CITY OF HAMILTON
 Building Division

Permit No. 17-131925

HIGHGROVE-1
COMPLIANCE PACKAGE 'A1'

Greenpark. HIGHGROVE 1
 project name: RUSSELL GARDENS PH2 municipality: WATERDOWN, ON. project no.: 16036
 date: APRIL 2017 checked by: scale: 3/16" = 1'-0" drawing no.: A0
 TYPICAL NOTES AND AREAS
 16036-HIGHGROVE 1
 16036-HIGHGROVE 1.dwg - Nov - Sep 25 2017 - 5:06 PM
 All drawings, specifications, related documents and design are the copyright property of VAS DESIGN. Reproduction of this property in whole or in part is strictly prohibited without VAS DESIGN's written permission.

GROUND FLOOR PLAN - ELEV. 1

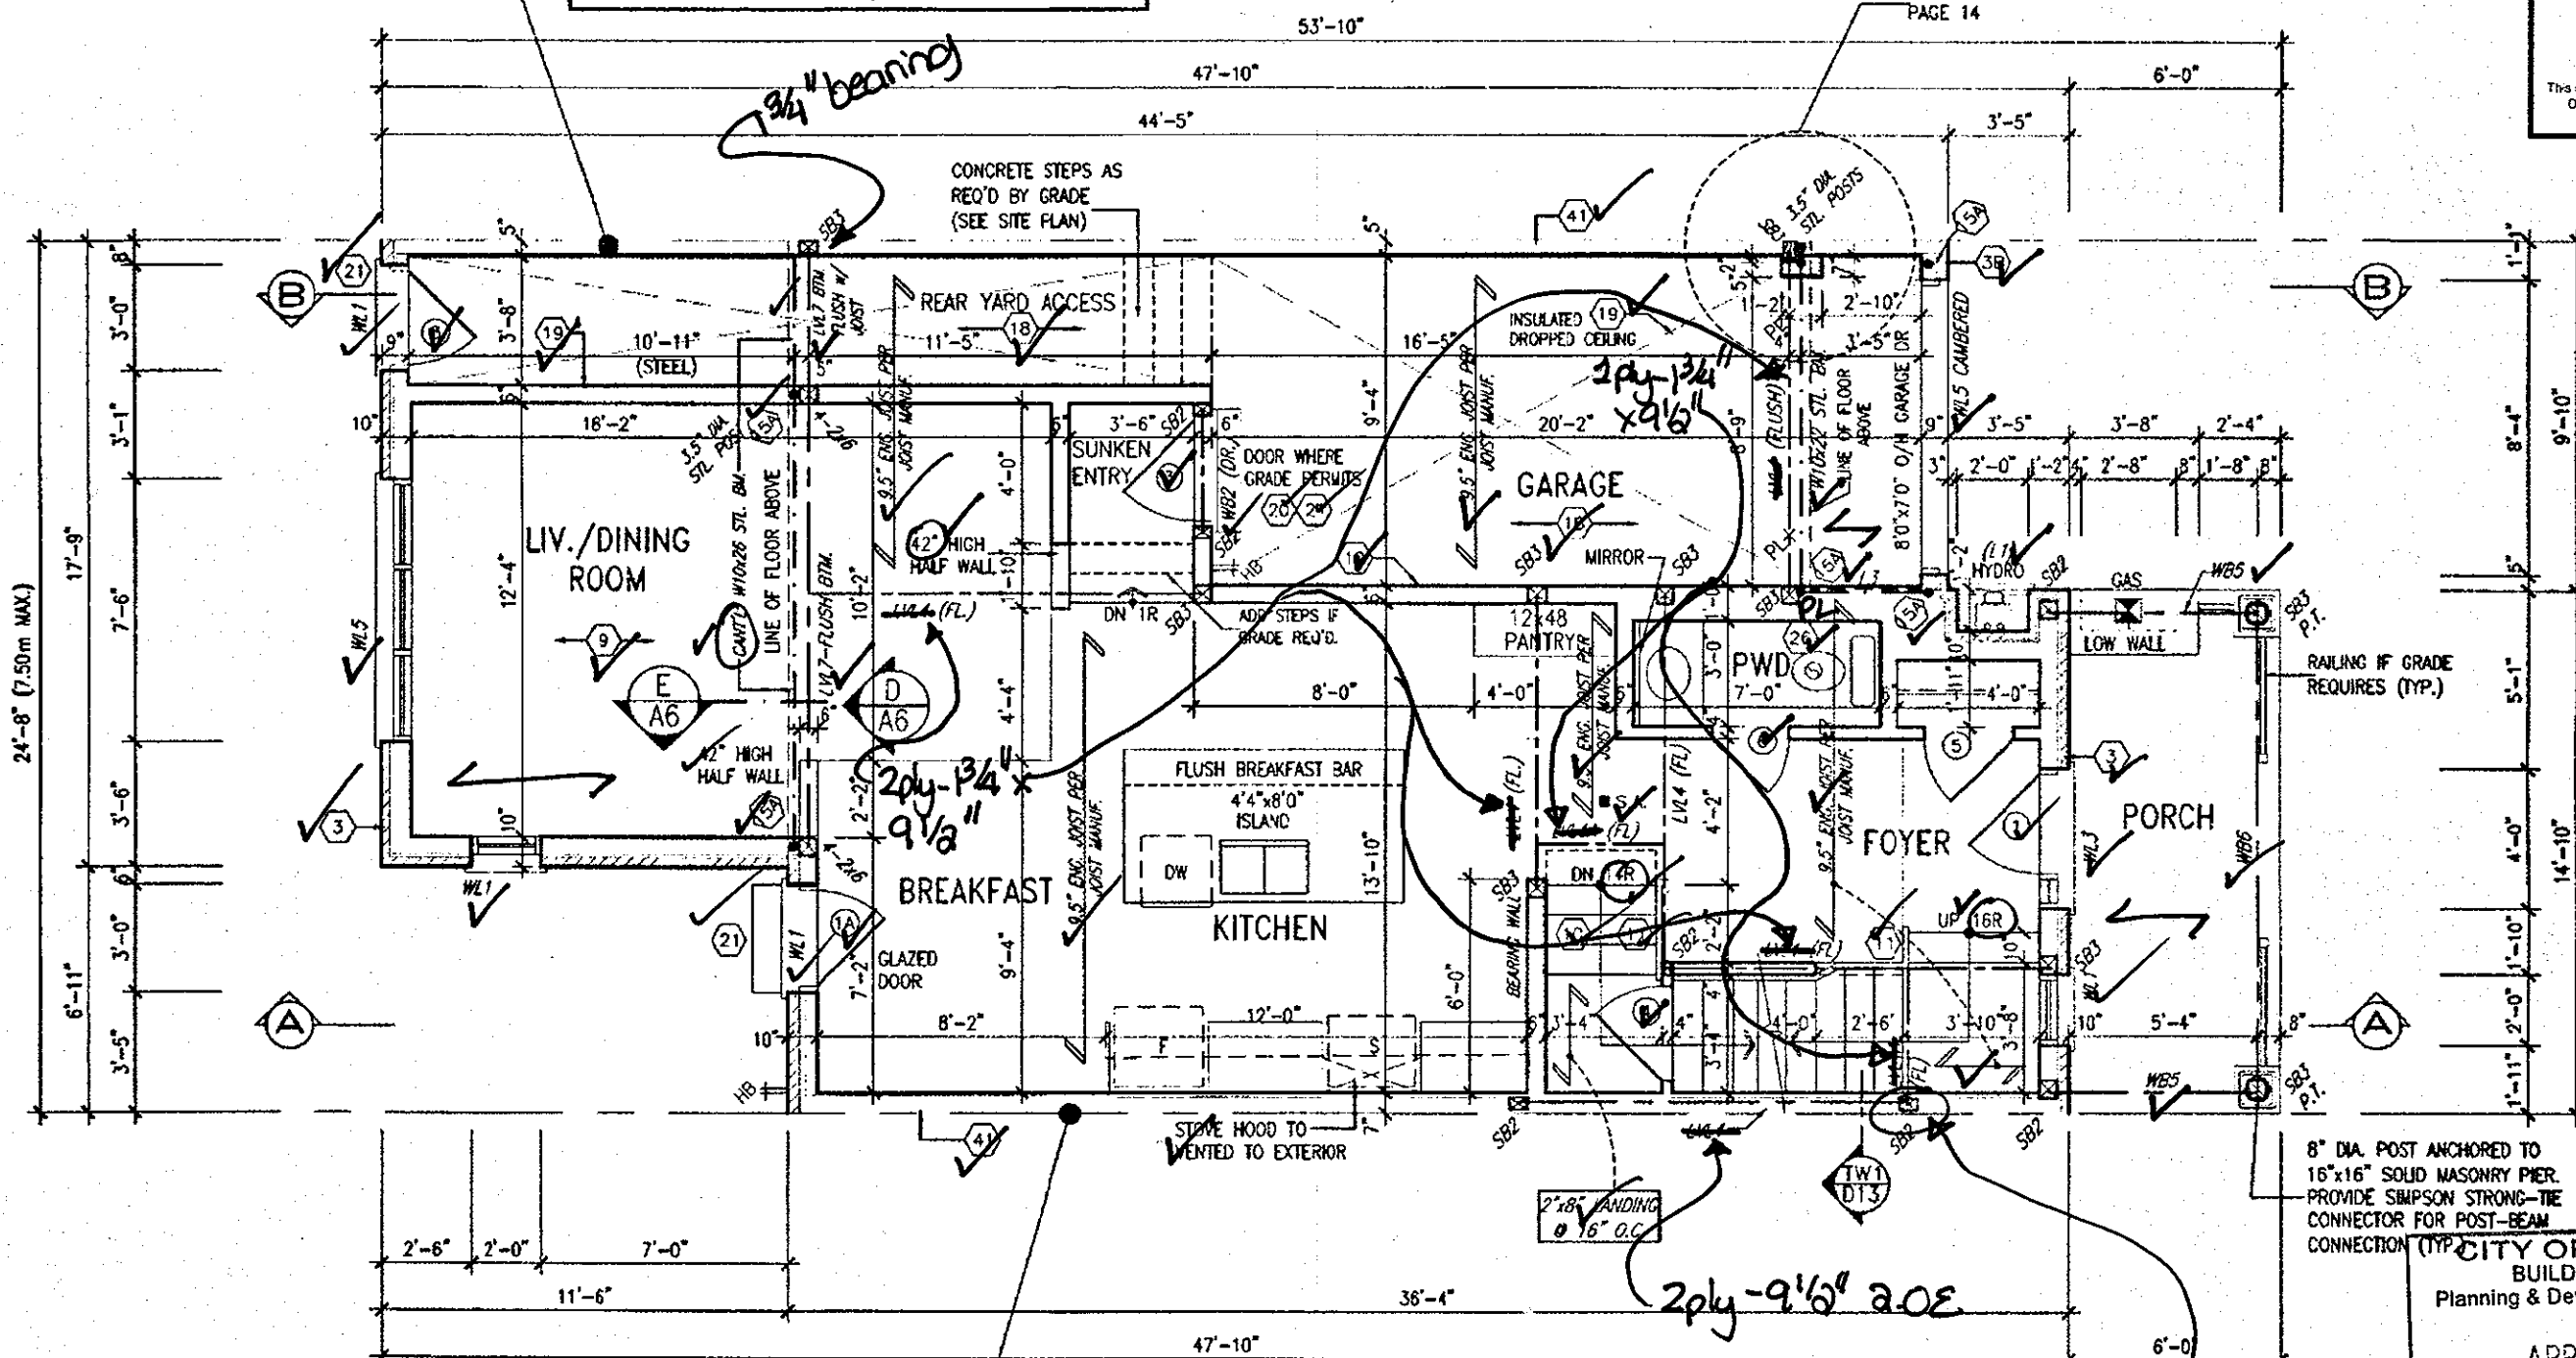
2x6 wall required
for beam (3x8") bearing

SECTION A-A
ELEV. 1

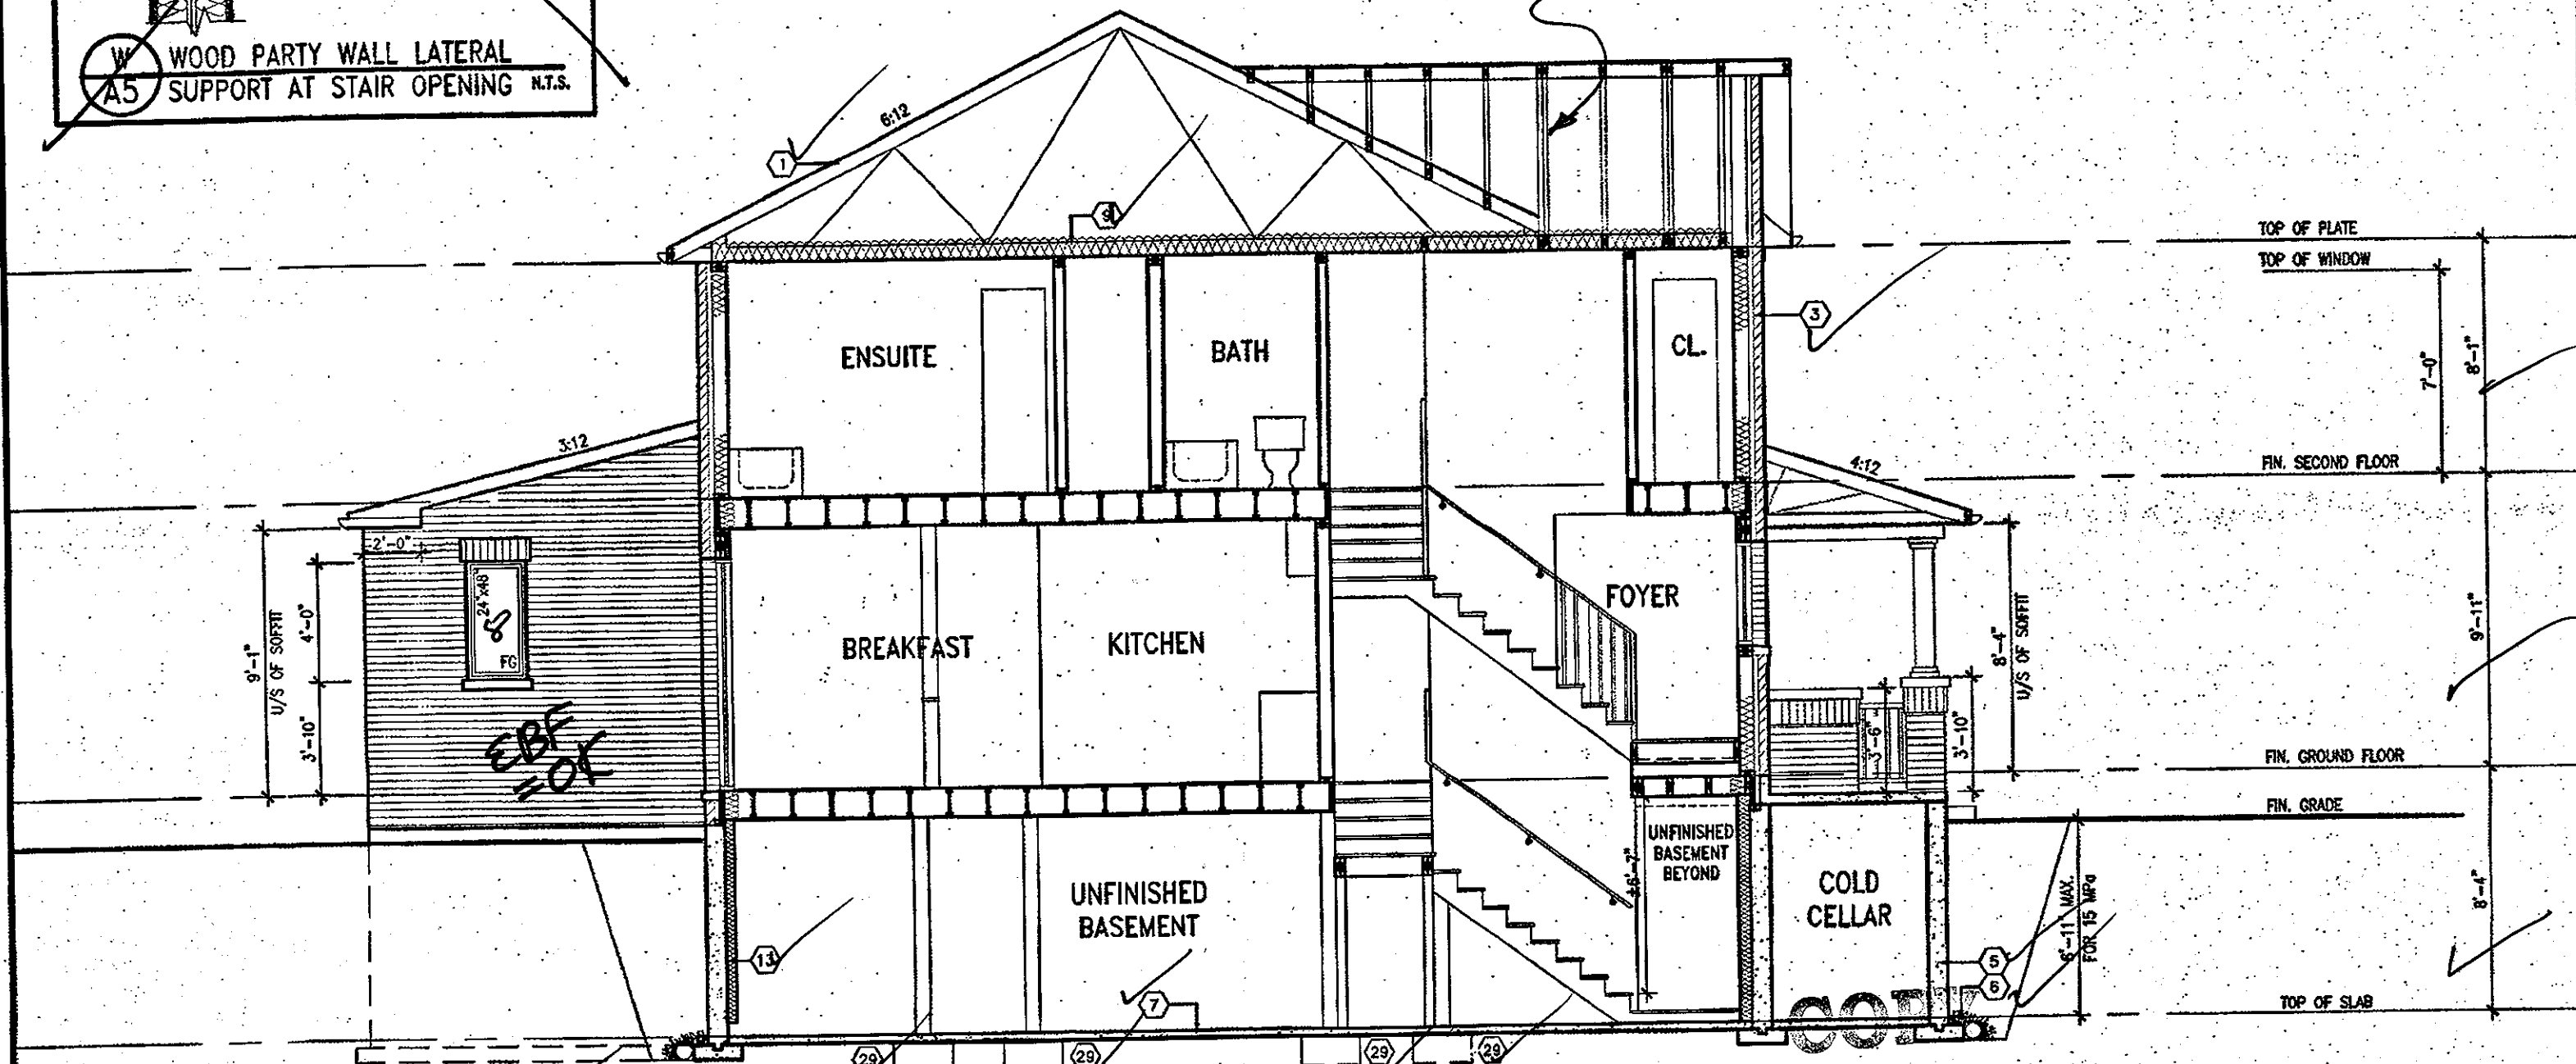
*See tall wall detail

HIGHGROVE 1
municipality
WATERDOWN, ON.
project no.
16036
PART. PLANS- DECK CONDITION
16036-HIGHGROVE 1
drawing no.
A7

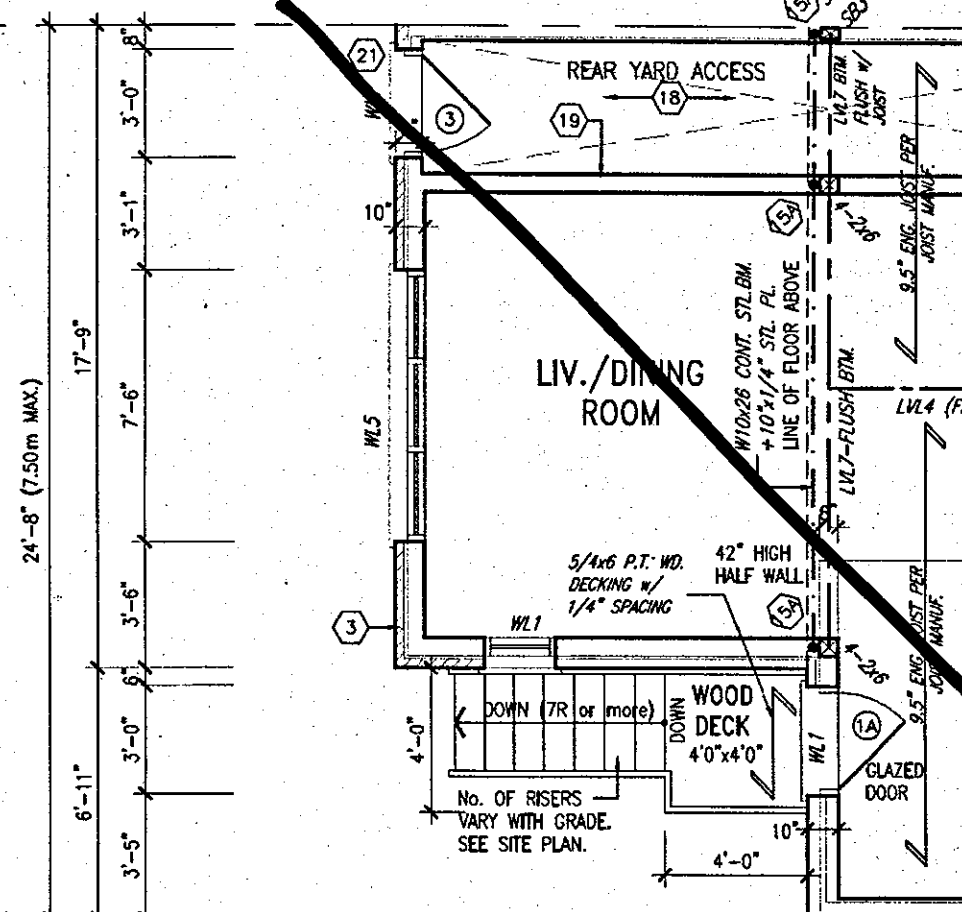
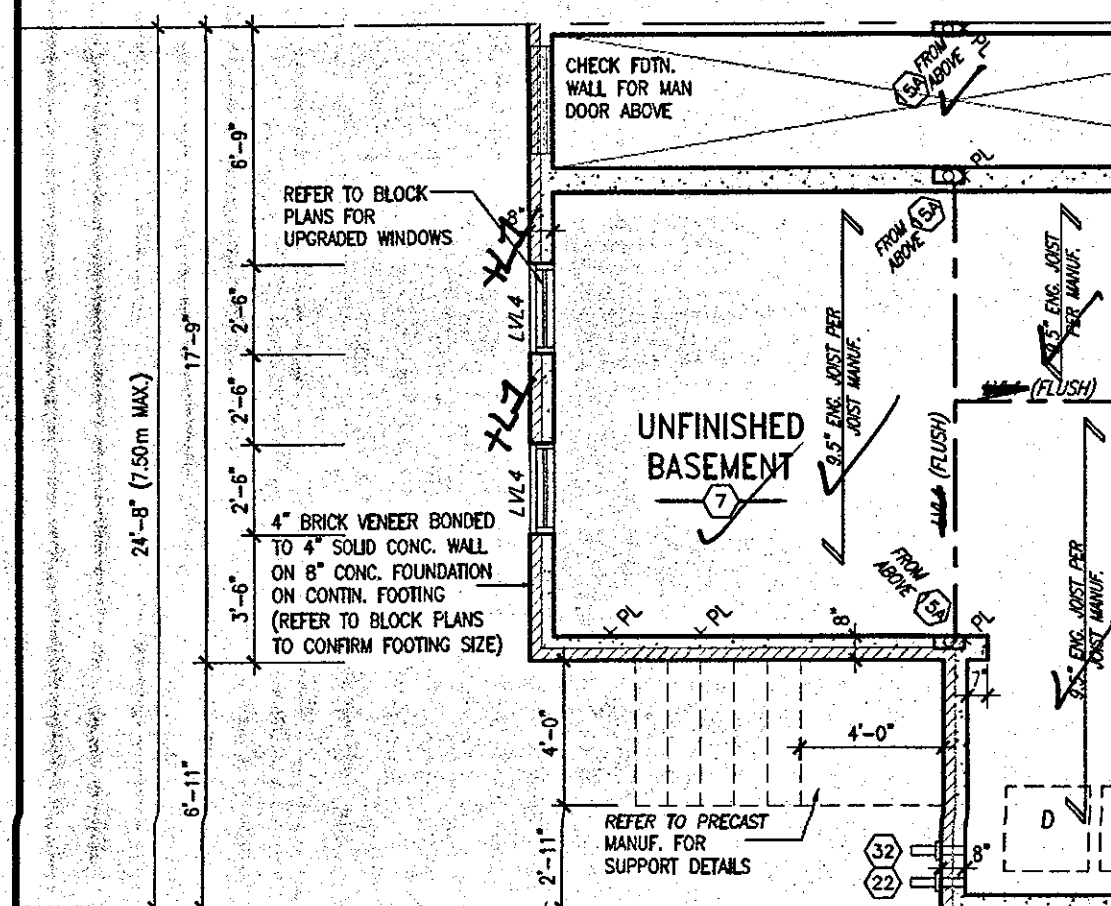
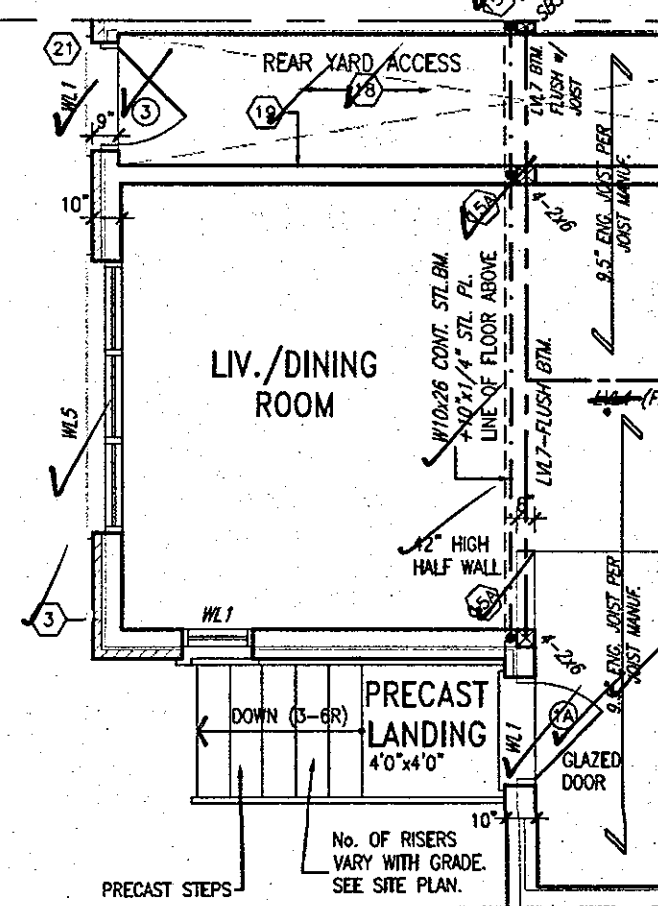
*beams sizes
as per
main plans*
